THERMOSTAT CHANGE FOR KIT #1039086

TO REPLACE 9920450 THERMOSTAT WITH 9920434 THERMOSTAT (ALL STYLE OF BREWMATIC BREWERS EXCEPT DIPLOMAT II & VI MODELS)

THERMOSTAT CHANGE REV. A 4/04 INSTRU. #9600199

TYPICAL ELECTRICAL CONNECTIONS FOR THERMOSTAT #9920434 REPLACING THERMOSTAT #9920450

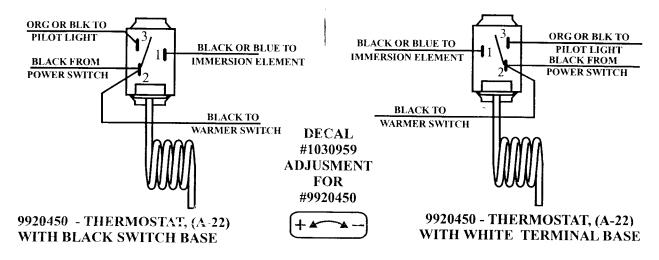
#9920450 THERMOSTAT WITH TYPICAL ELECTRICAL CONNECTIONS

- 1. TURN BREWER POWER SWITCH TO THE OFF POSITION.
- 2. UNPLUG BREWER LEADCORD FROM ELECTRICAL WALL OUTLET.
- 3. DISCONNECT THE OLD THERMOSTAT #9920450.
- 4. REMOVE ANY EXISTING LABELS THAT REFFER TO THE THERMOSTAT #9920450 ADJUSTMENT.
- 5. INSTALL THE NEW THERMOSTAT #9920434 PROVIDED WITH THIS KIT.
- 6. RECONNECT THE NEW THERMOSTAT ACCORDING TO THE DIAGRAMS ABOVE, PROVIDED WITH THIS KIT.
- 7. USE THE WIRES AND THE CONNECTORS SUPPLIED AS NEEDED.
- 8. APPLY THE NEW SUPPLIED LABEL, #9904236, SHOWING THE ADJUSTMENT FOR THE NEW THERMOSTAT. (NEW LABEL SHOWS TEMPERATURE ADJUSTMENT IS MADE IN OPPOSITE DIRECTION.)
- 9. PLUG BREWER LEADCORD INTO ELECTRICAL WALL OUTLET.
- 10. TURN BREWER POWER SWITCH TO THE ON POSITION.
- 11. TEST THE COFFEE BREWER AND MAKE TEMPERATURE ADJUSTMENTS AS NEEDED (SEE MANUALS).
